XtremeAir GmbH, Harzstr.2, D-39444 Hecklingen Tel: +49 39267 60999 0, Fax: +49 39267 60999 20 www.xtremeair.de info@xtremeair.de	Document No. SB-XA42-2018-017
		Issue: A.01
DOA-Nr.: EASA.21J.360	Service Bulletin	Date: 27.09.2018

Subject:	Front baffling improvement
Aircraft type affected:	XA42
Serial numbers affected:	MSN 132 and 137 – 151
Compliance:	At user discretion
Time of Compliance:	During the next scheduled maintenance
Purpose:	To notify the owner of the subject aircraft of an improvement of the LH front baffling.
Background:	A narrow gap between the LH and RH front baffling and the lower cowling leads to rubbing and wearing of the baffle seal. Damage of the lower cowling could occur.
Manpower:	It is estimated that four (4) man-hours are necessary to apply this service bulletin.
Materials:	<p>The following materials are necessary and can be ordered through spares@xtremeair.de:</p> <ul style="list-style-type: none"> (1) ea. XA42-7510-215 E.00 Front sheet metal plate RH (1) ea. XA42-7510-217 C.00 Front attachment slat RH (12) ea. DIN7337-A-4x8 Aluminum pop rivet – or equivalent – (8) ea. MS20470AD4-4 Universal head rivet

Figure 1: Identification of the baffle assemblies XA42-7510-051/-054

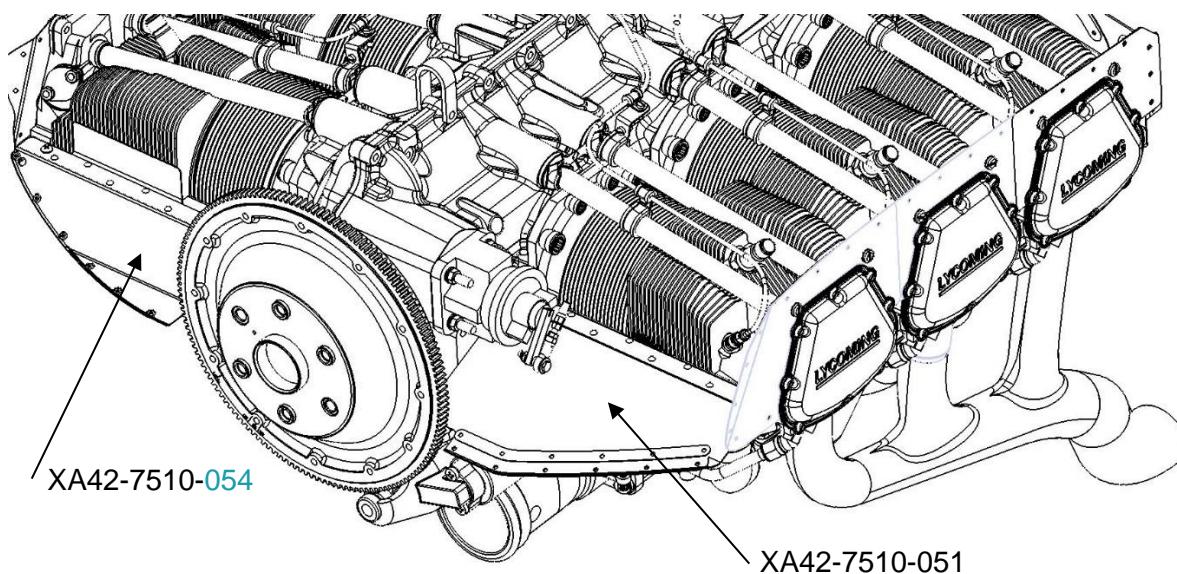
Consumables:	<ul style="list-style-type: none"> - Silicone baffle seal 1/8" x 2"
Accomplishment Instructions:	<p>Read all the instructions and make sure the complete procedure is understood before starting the assembly work on the aircraft. In case of doubt, contact the manufacturer.</p> <ol style="list-style-type: none"> 1. Remove the lower cowling in accordance with chapter 71-10-02 of the AMM. <p>LH baffle:</p> <ol style="list-style-type: none"> 2. Remove the LH front baffle assy. XA42-7510-051. Refer to Figure 1 for identification.

11. Remove the RH front baffle assy. XA42-7510-054. Refer to Figure 1 for identification.
12. Drill out all 6 pop rivets and remove the silicone rubber and reinforcement strap.
13. Cut out a baffle seal using the old one as a template.
14. Drill out all 8 universal head rivets and remove the front sheet metal plate XA42-7510-215.
15. Attach the delivered front baffle sheet metal plate Rev. E.00 to the front baffle assy. using MS20470AD4-4 universal head rivet.
16. Attach the baffle seal with the delivered reinforcement strap XA42-7510-217 Rev C.00 to the front baffle using DIN7337 – A – 4x8 pop rivets.
17. Reassemble all items in the reverse order.

Figure 2: Marking of the trim contour

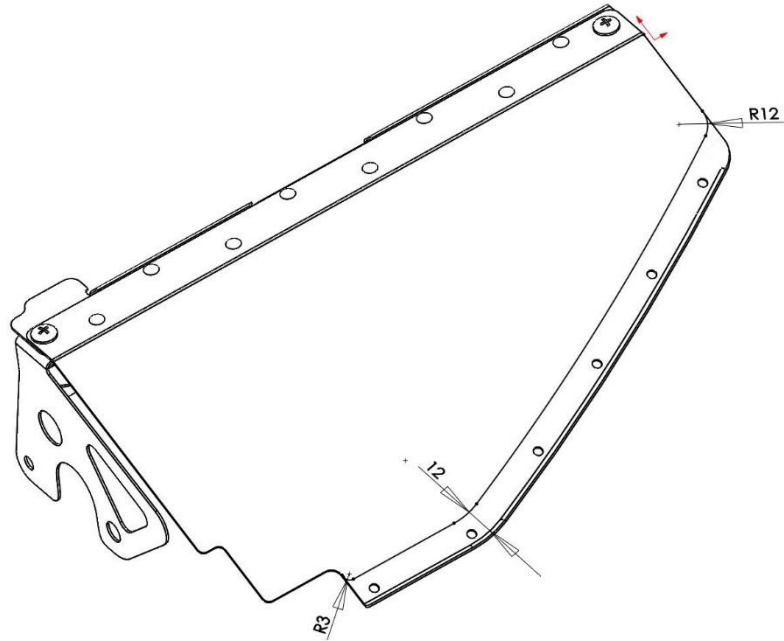
3. Drill out all 6 pop rivets and remove the silicone rubber and reinforcement strap.
4. Mark the contour to be trimmed in accordance with Figure 2. It is also possible to use the reinforcement strap as a template.
5. Trim the front baffle.
6. Use the reinforcement strap to mark the position of the pop rivets.
7. Drill dia. 4,1mm holes at the marked positions.
8. Flange the front edge of the baffle similar to the previous edge. Refer to Figure 4 for approximate flanging dimensions.
9. Cut out a baffle seal using the old one as a template.
10. Attach the baffle seal with the reinforcement strap to the front baffle using the DIN7337 – A – 4x8 pop rivets.
